**WHITEMARSH TOWNSHIP
SHADE TREE COMMISSION MEETING AGENDA
FEBRUARY 3, 2026 AT 6:30 PM (IN-PERSON)**

- Grading Permit #2025-22 Stenton Ave. Trust; Construction of Single-Family Dwelling & Associated Improvements; PARCEL ID 65-00-11131-009

EARTH DISTURBANCE PERMIT PLAN SET

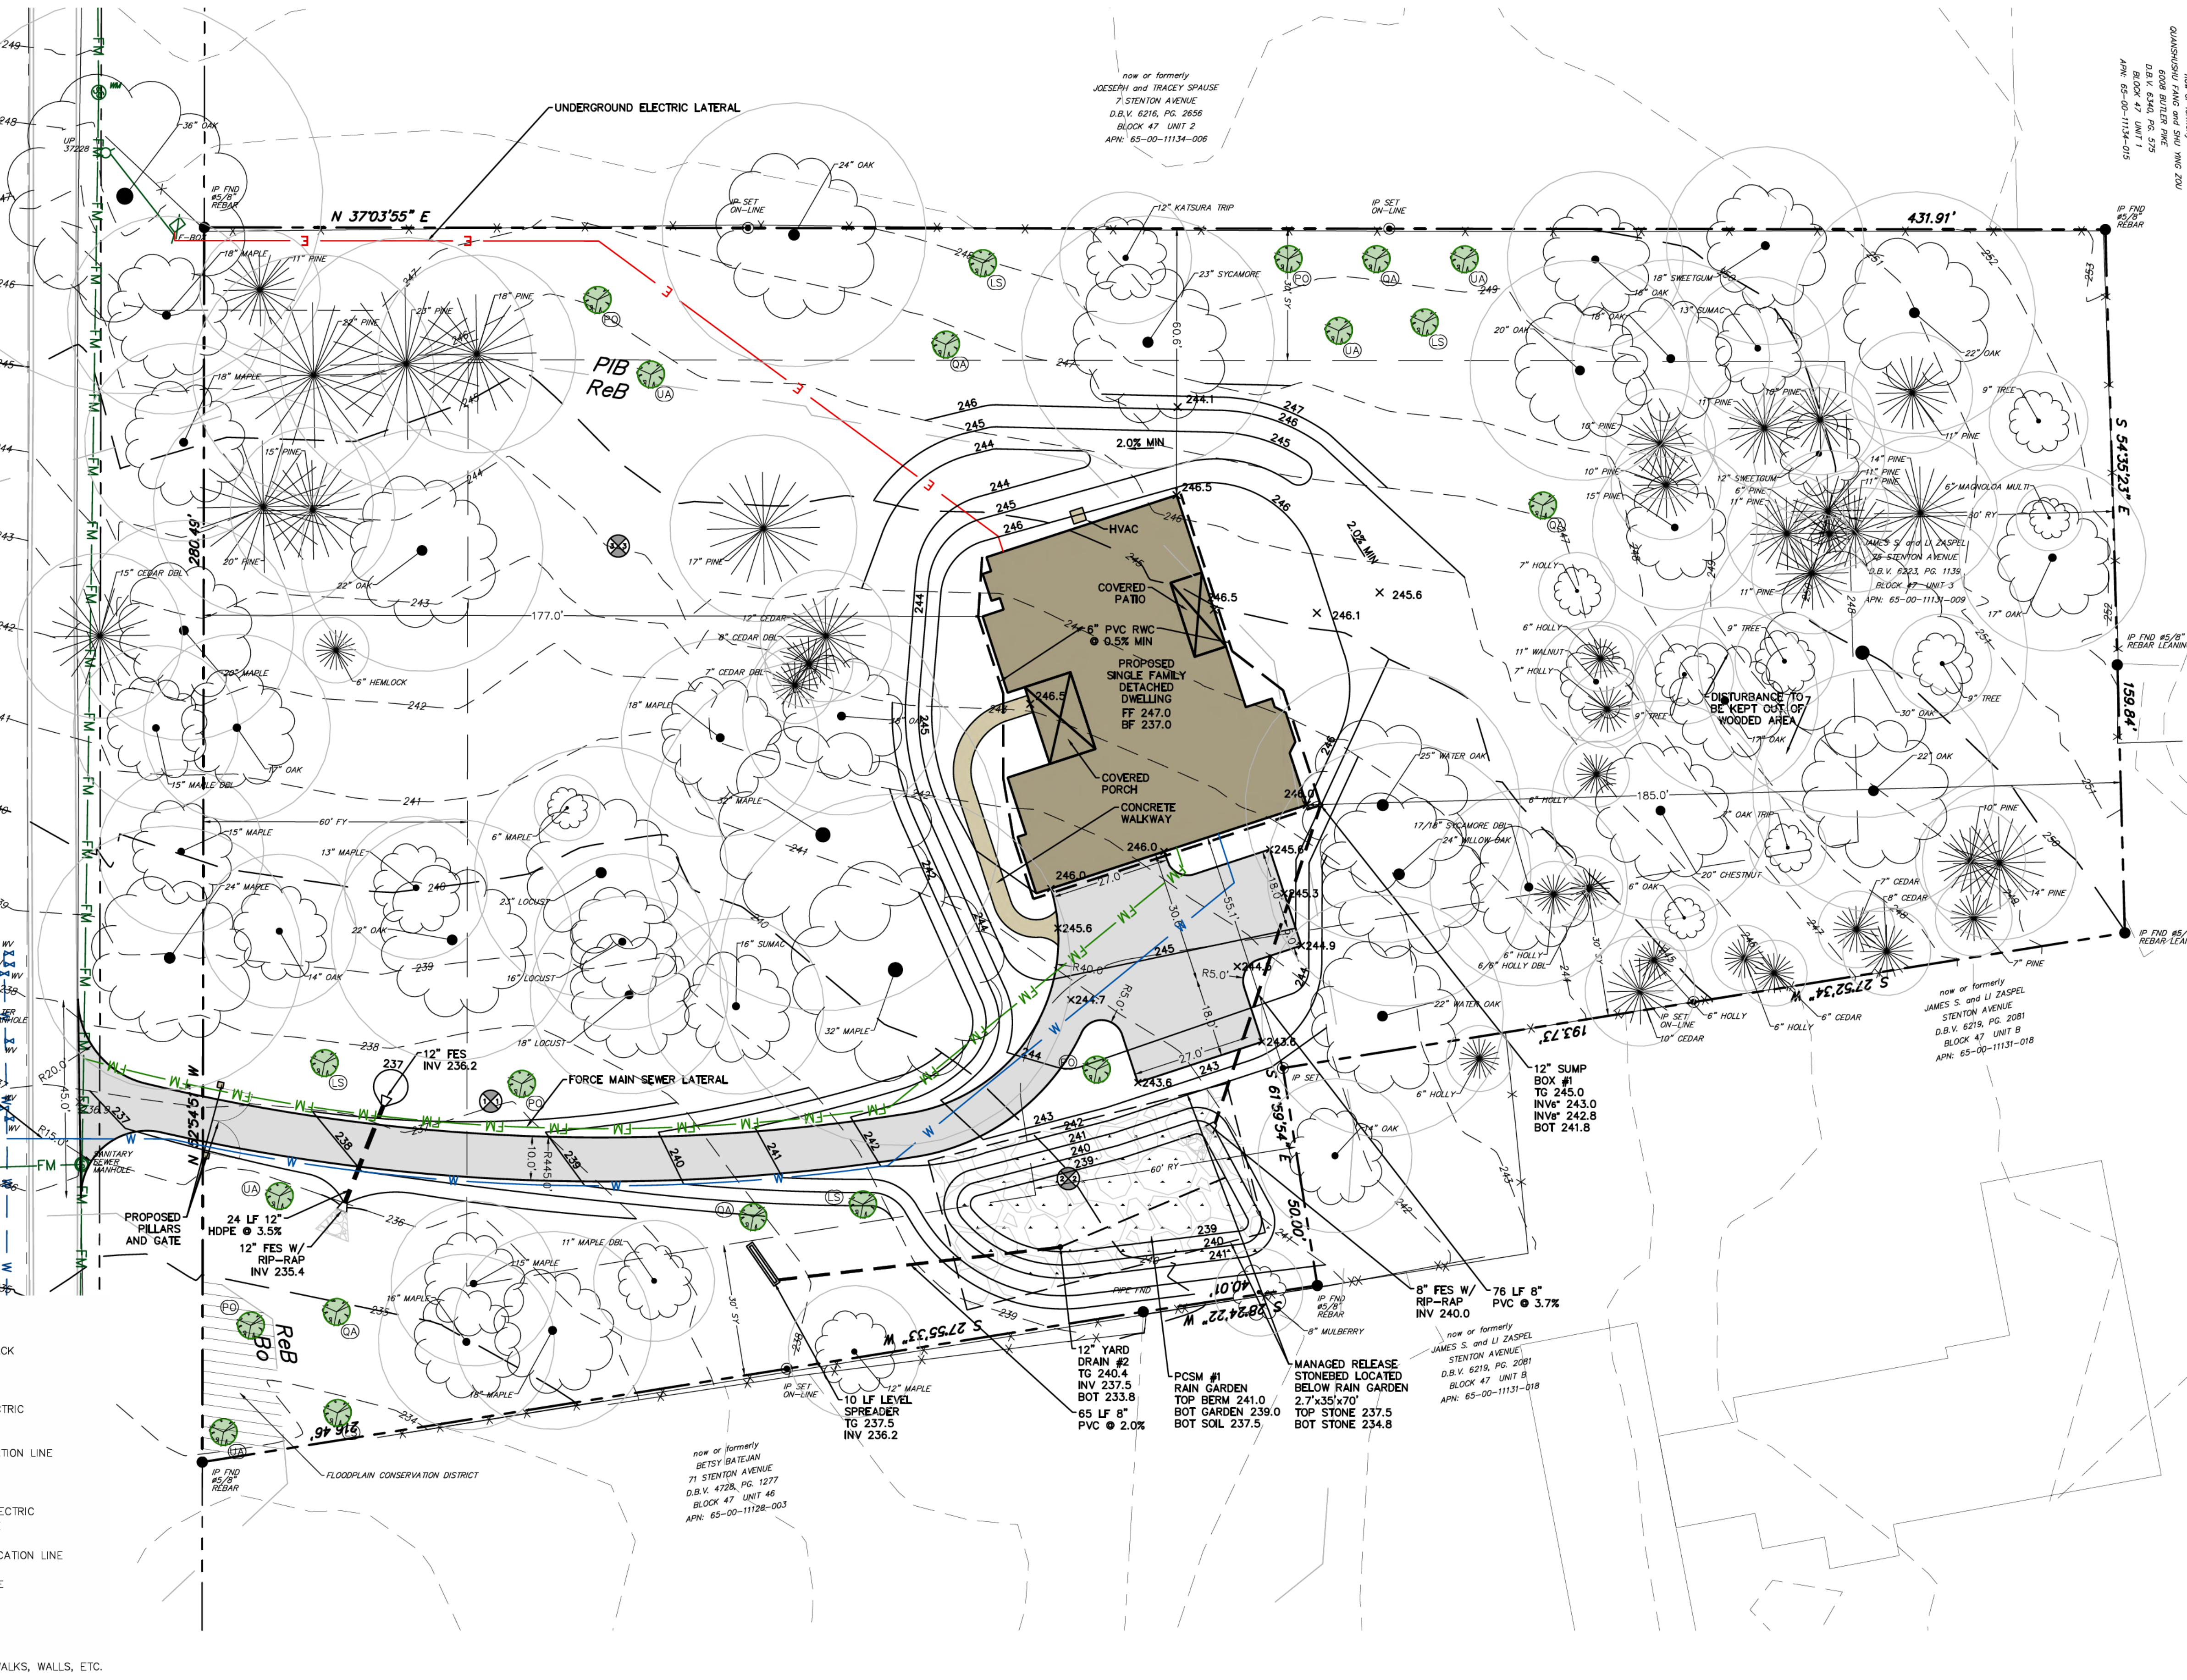
<u>Section</u>	<u>Description</u>
3. 55-4(C)	This section of the ordinance requires that the tree survey plan shall be reviewed by the Shade Tree Commission in a public meeting.
4. 55-4(C)(4)(b)	The plans show tree protection fencing within the root protection zone, as established by one of the following two means, whichever is greater: [1] Calculated at 1.25 feet (radius) per one inch of (DBH) diameter breast height. [2] A circle with a radius extending from a tree's trunk to a point no less than the furthest crown dripline.

The revised plan indicates that tree protection fencing is proposed. While this is appropriate in principle, several locations do not fully comply with the minimum setback requirements established under Chapter 55.

SHEET NO.: **POST CONSTRUCTION STORMWATER MANAGEMENT NOTES & DETAILS**

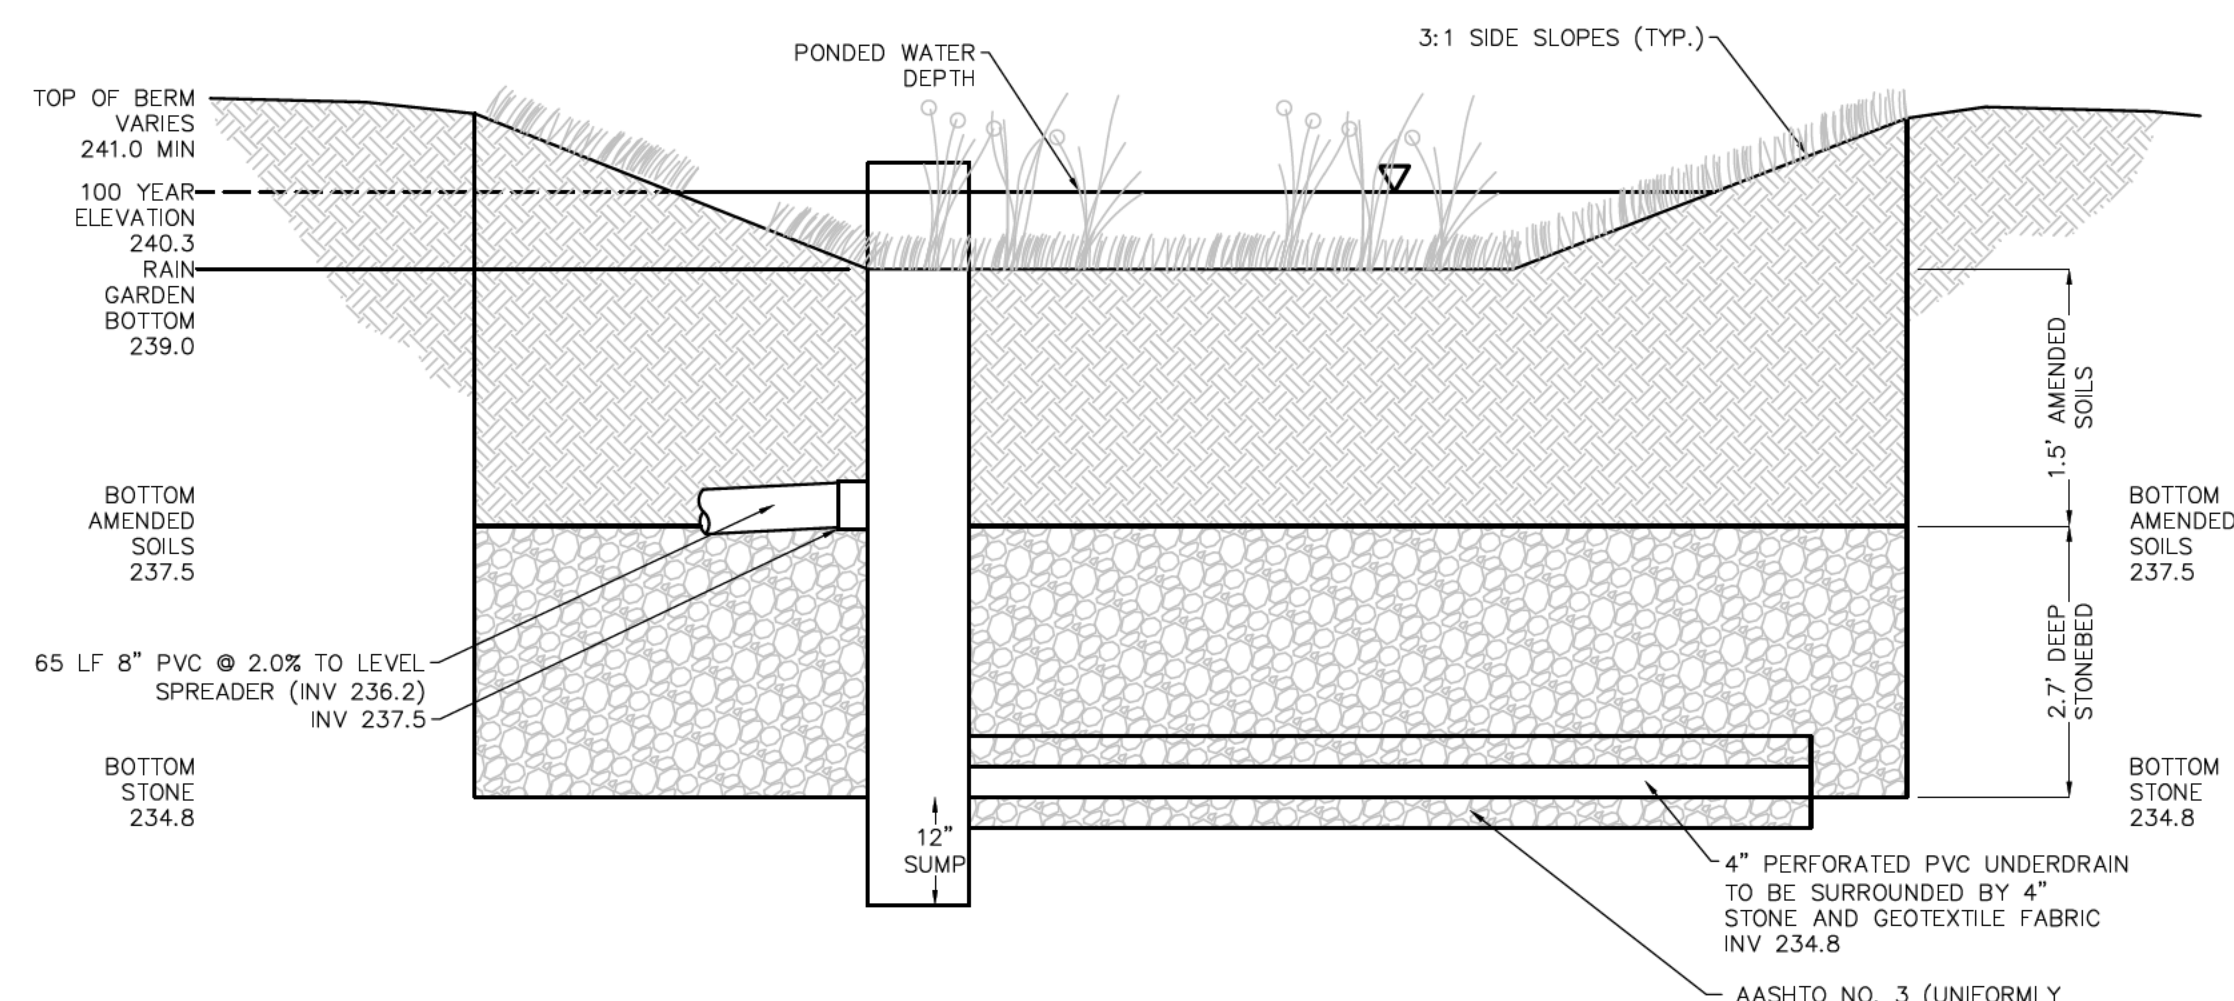
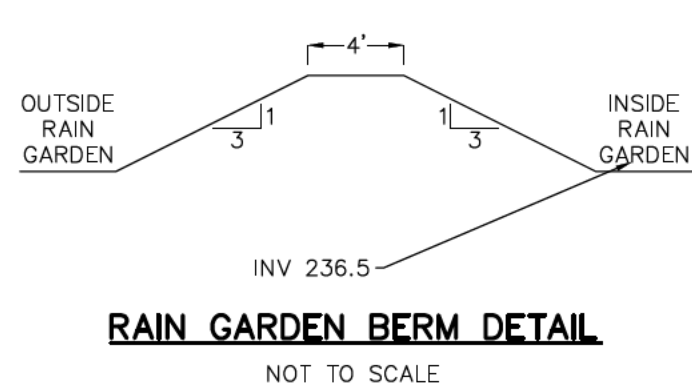
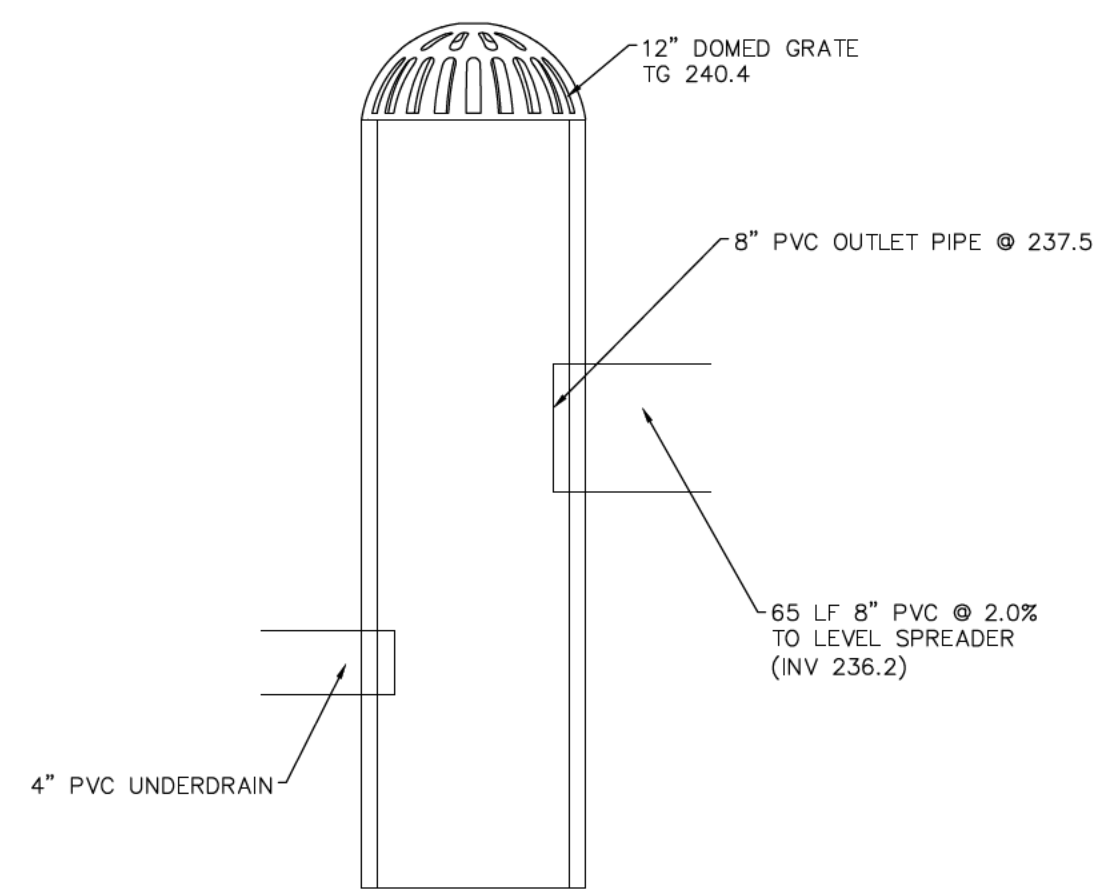
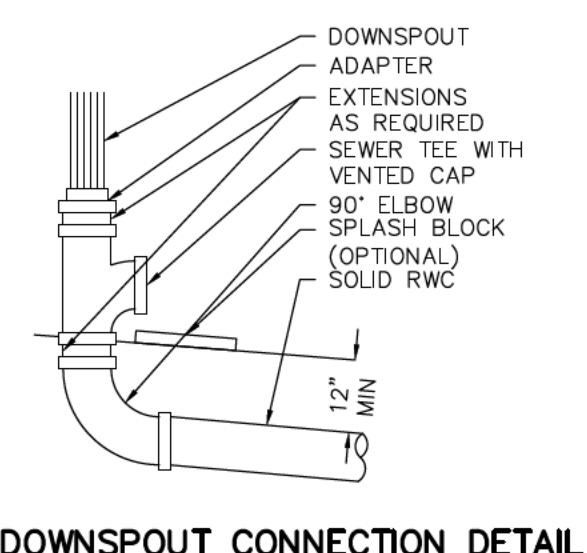
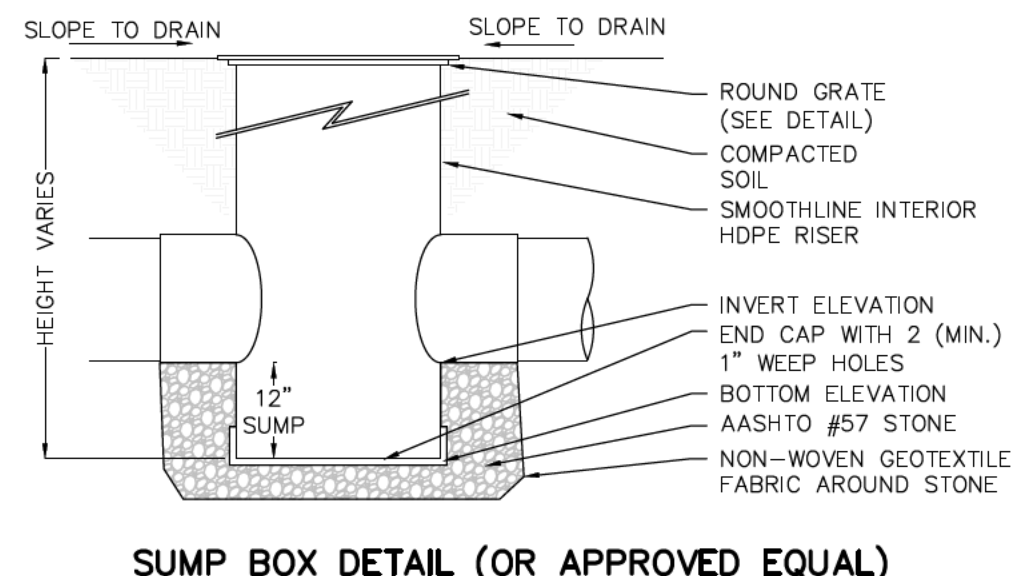
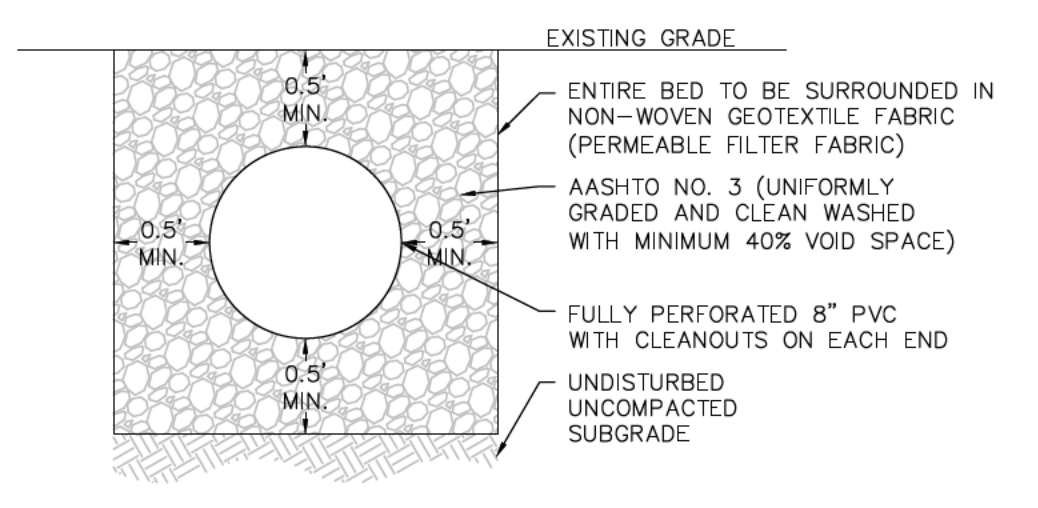
<u>Section</u>	<u>Description</u>
1. 58-17	There is an errant dimension label over the Post Construction Stormwater Management Installation Note on Sheet 2, which must be removed. The Construction Notes on Sheet 2 must be revised as follows: <ul style="list-style-type: none">Note 3 must be revised to state that the permit is required from PennDOT.Note 4 must be revised to state that the permit is required from the Whitemarsh Authority.
2. 58-28(D)(11)	The plans must be revised so that the proposed contour line representing an elevation of 241, near the stormwater BMP, does not extend off of the subject property.
